RE: LOT 58, PENN SQUARE REVISED DRAINAGE PLAN

**NEW MEXICO
EDUCATORS
SERVICE CORP.**
7517 Montgomery NE
Albuquerque, New Mexico

GRADING PLAN

DRAINAGE PLAN, CALCULATIONS,
SECTIONS AND DETAILS

DRAWING NO.
C2.1
SHEET OF

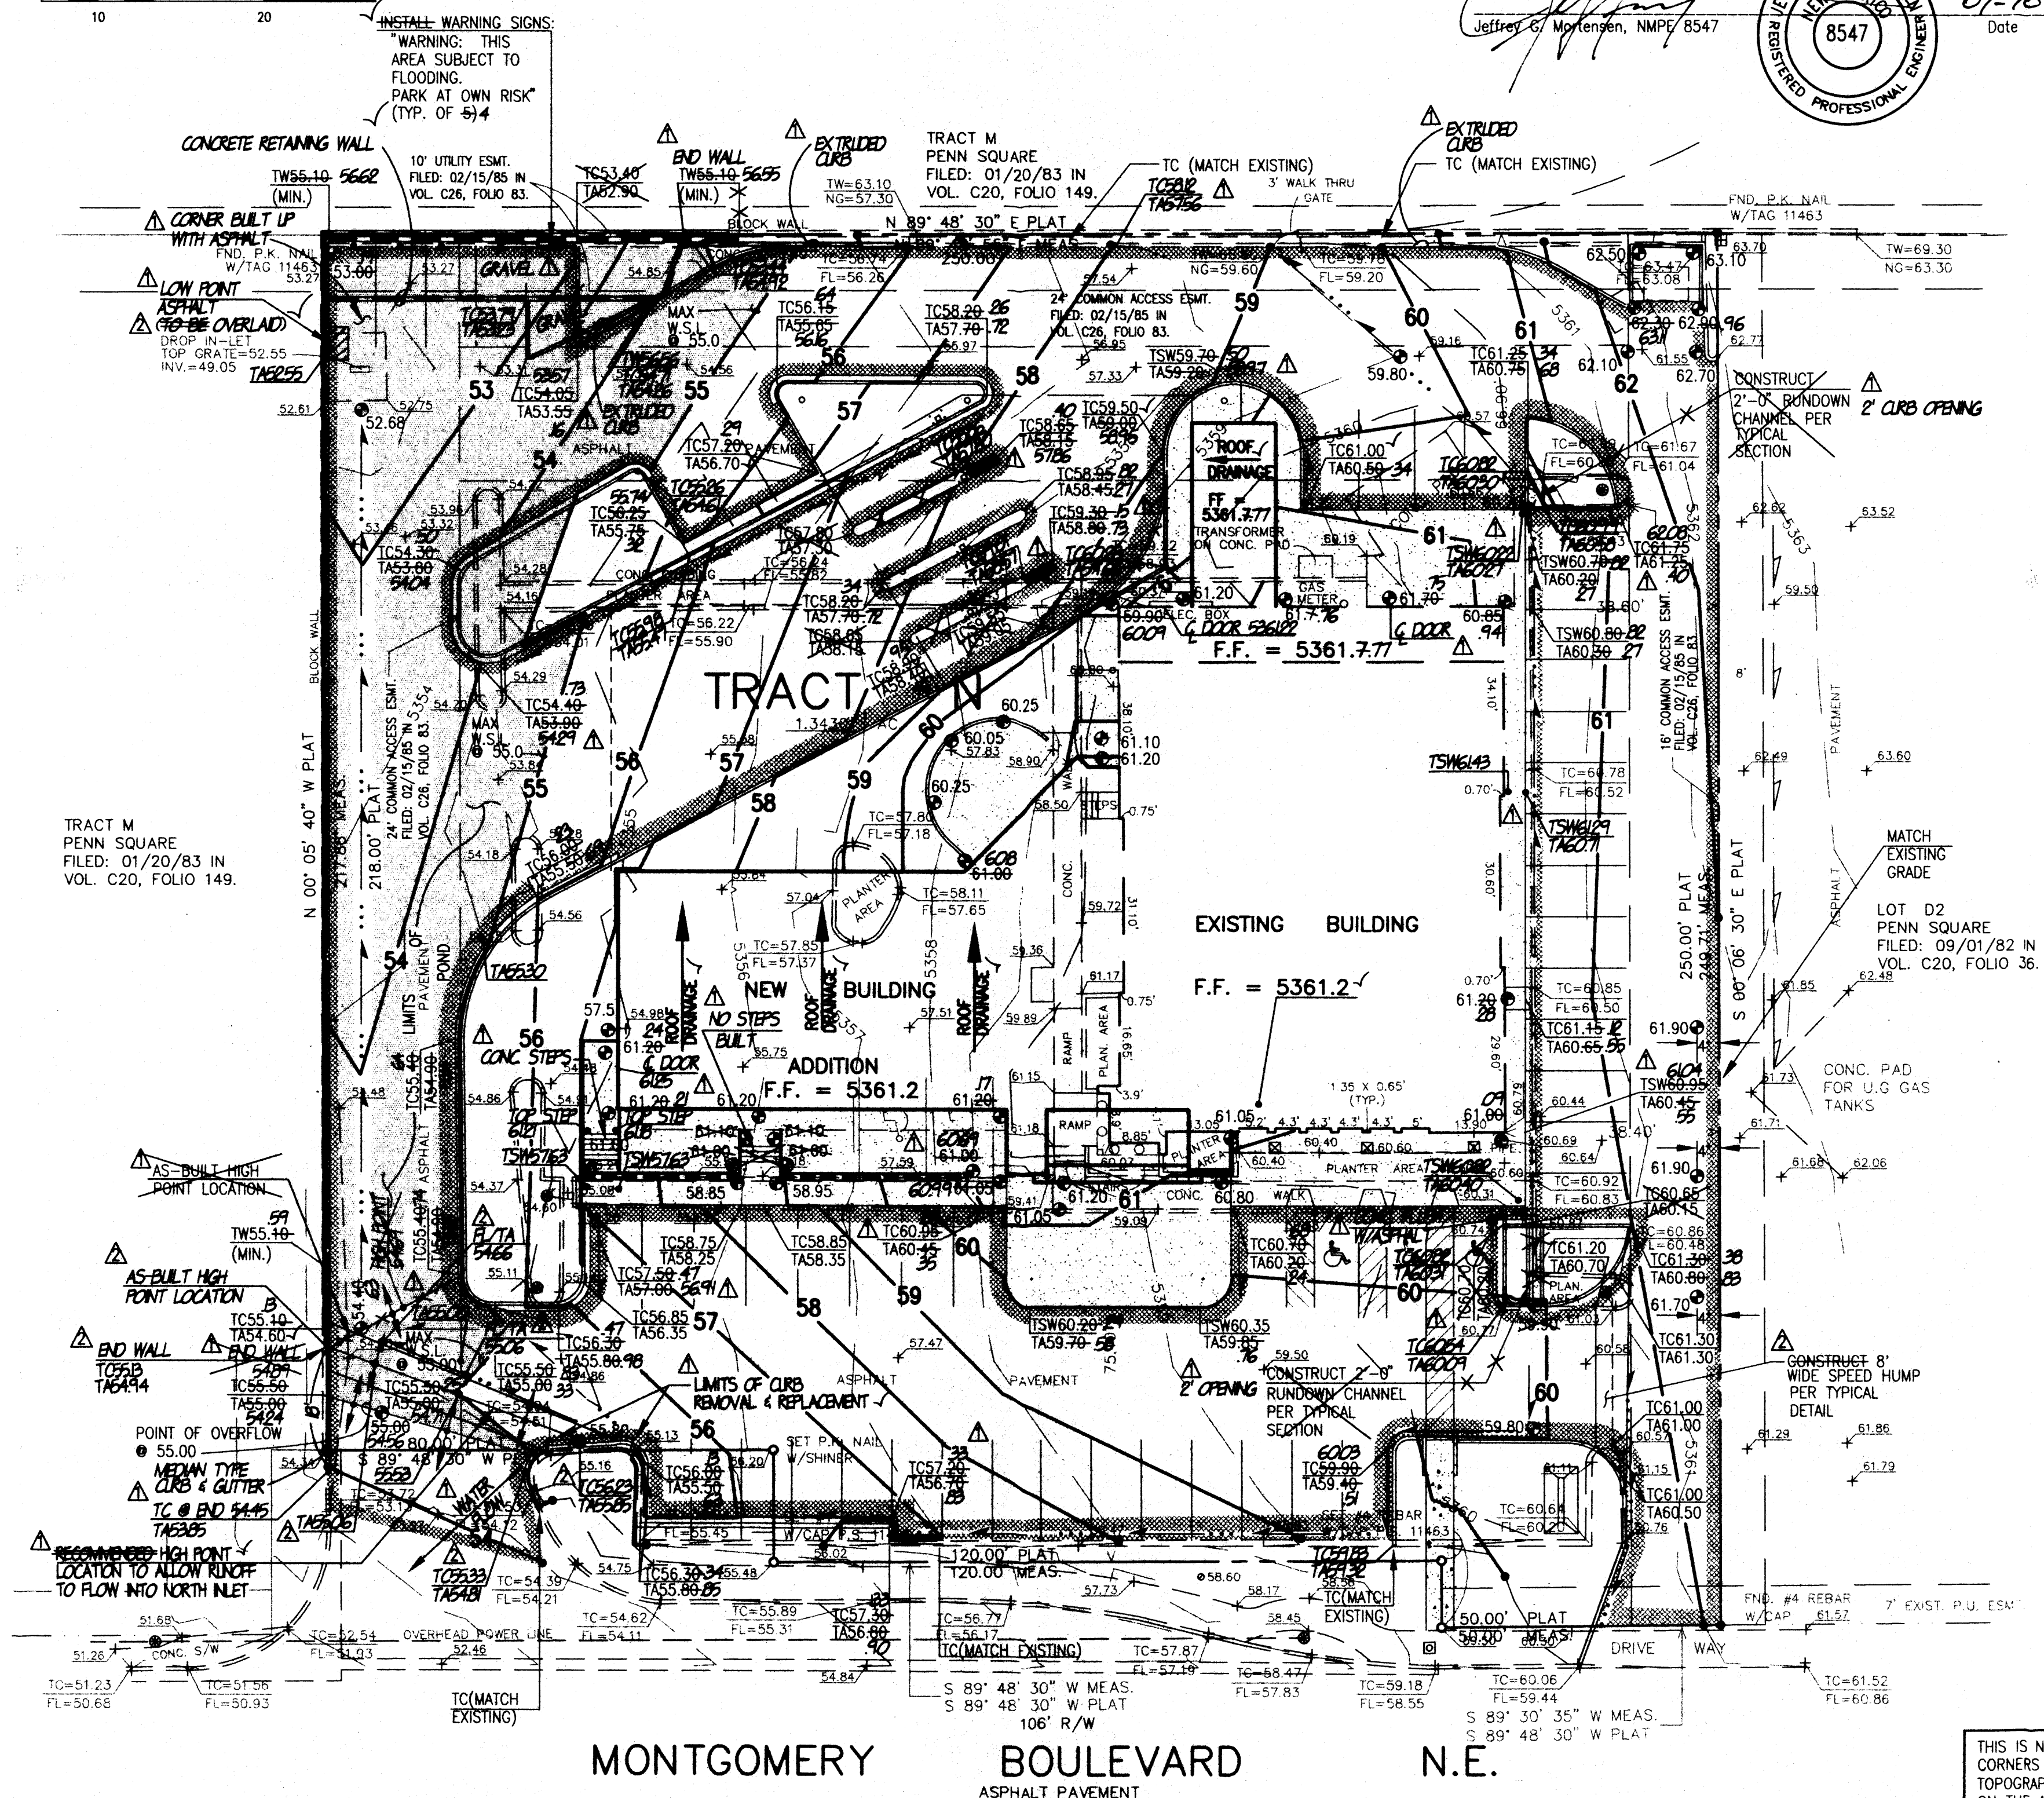
- The speed hump located near the southeast corner of the site was not built. The speed hump must be built to be in compliance with the approved Master Drainage Plan so that offsite flows from the east do not enter the site.
- The waterblock at the southwest entrance to the site was constructed incorrectly. This allows the southern portion of the site to drain directly onto Montgomery Blvd. N.E. This area must be reconstructed to satisfy the intent of the approved plan.
- There is a birdbath in the asphalt paving north of the existing storm inlet. The contractor must overlay this area to remove the birdbath and provide positive drainage to the inlet.

It is based upon the information and recommendations presented hereon that issuance of a Temporary Certificate of Occupancy is hereby recommended. The Contractor has indicated that 30 days will be sufficient time in which to accomplish the corrections following which a recertification will be submitted. The information shown hereon was obtained by me or under my direct supervision and is true and correct to the best of my knowledge and belief.

TYPICAL SPEED HUMP DETAIL
SCALE: 1" = 5'-0" (NOT BUILT)

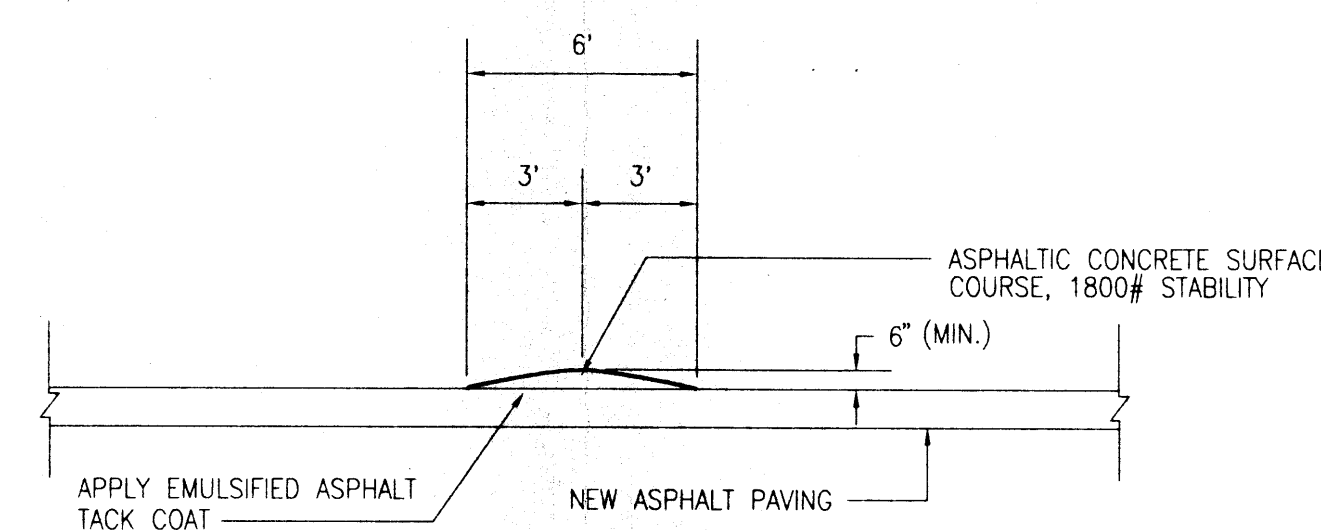
- The speed hump located near the southeast corner of the site was not built. The speed hump must be built to be in compliance with the approved Master Drainage Plan so that offsite flows from the east do not enter the site.
- The waterblock at the southwest entrance to the site was constructed incorrectly. This allows the southern portion of the site to drain directly onto Montgomery Blvd. N.E. This area must be reconstructed to satisfy the intent of the approved plan.
- There is a birdbath in the asphalt paving north of the existing storm inlet. The contractor must overlay this area to remove the birdbath and provide positive drainage to the inlet.
